Access Compliance Report

Public Rights-of-Way

Intersection ID: 52698	Main Street: JOSEPHINE_CT	Cross Street: MECKLENBURG_AV	Location: SE
ADA ID: 3BB1CD85C660	Ramp Type: PerpDiag	Initial Pass/Fail: Fail	Overall Compliance: No
Severity Score: 8.75			
Codes/Mitigation Info/Possible Solution		Field Measurements/Component Compliance

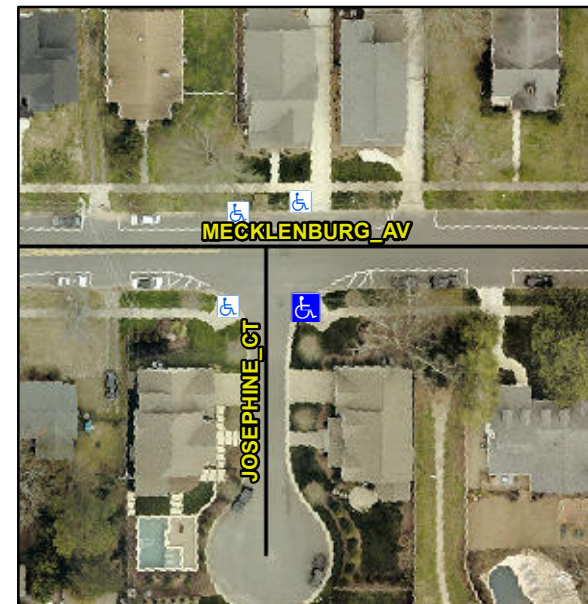
Not Found, R304.5.1

Compliance	Description	Data	Compliance	Description	Data
N/A	Ramp Length (in)	117.0	Yes	Ramp Slope (%)	6.5
No	Ramp Width (in)	47.0	Yes	Ramp XSlope (%)	1.0
N/A	Flare Type LT	N/A	N/A	Flare Type RT	N/A
N/A	Flare Slope LT (%)	N/A	N/A	Flare Slope RT (%)	N/A
N/A	Flare Traversable LT?	N/A	N/A	Flare Traversable RT?	N/A
N/A	Landing Length (in)	N/A	N/A	DWS Provided?	N/A
N/A	Landing Width (in)	N/A	N/A	DWS Contrast?	N/A
N/A	Landing Slope (%)	N/A	N/A	DWS Length (in)	N/A
N/A	Landing X Slope (%)	N/A	N/A	DWS Full Width?	N/A
N/A	Landing Curb? (Y/N)	N/A	N/A	DWS Offset (in)	N/A
N/A	Shared Landing?	N/A			
N/A	Gutter Ponding?	N/A	N/A	Gutter Slope (%)	N/A
N/A	Gutter Lip Ht (in)	N/A	N/A	Gutter X Slope (%)	N/A
N/A	Painted X Walk1?	No	N/A	Painted X Walk2?	No
	X Walk 1 Direction	To N		X Walk 2 Direction	To W
N/A	X Walk 1 Width (in)	N/A	N/A	X Walk 2 Width (in)	N/A
	X Walk 1 Slope (%)	1.8		X Walk 2 Slope (%)	0.8
	X Walk 1 X Slope (%)	0.4		X Walk 2 X Slope (%)	0.5

Remove & Replace Curb Ramp With Two New Directional Ramps or Equivalent.
